## EAL 2024 IRP Stakeholder Committee Questions

92. Referring to slide 9:

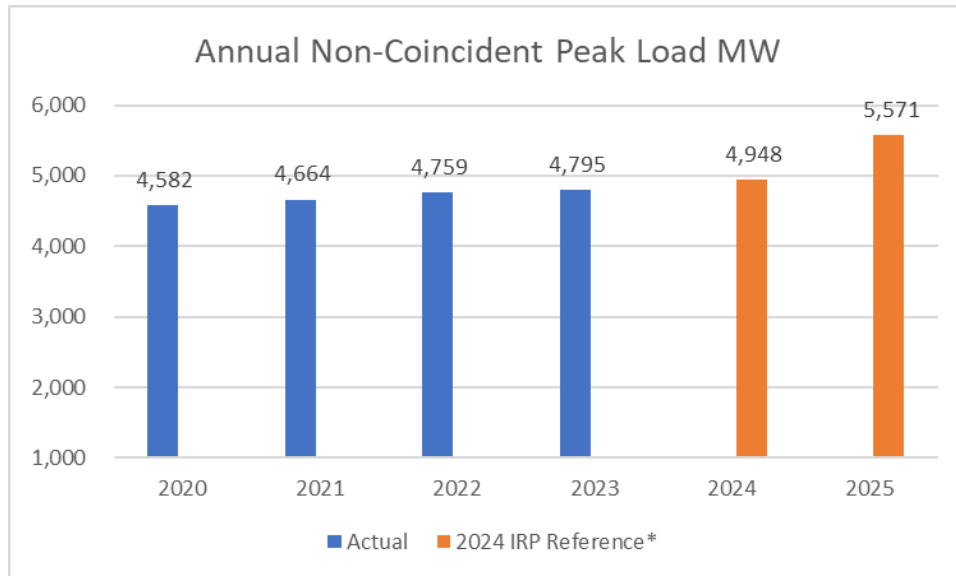
a. Please define and explain how EAL will pursue power resilience. What assets are used to secure power resilience?

See response to question No. 14. EAL evaluates options for power resiliency.
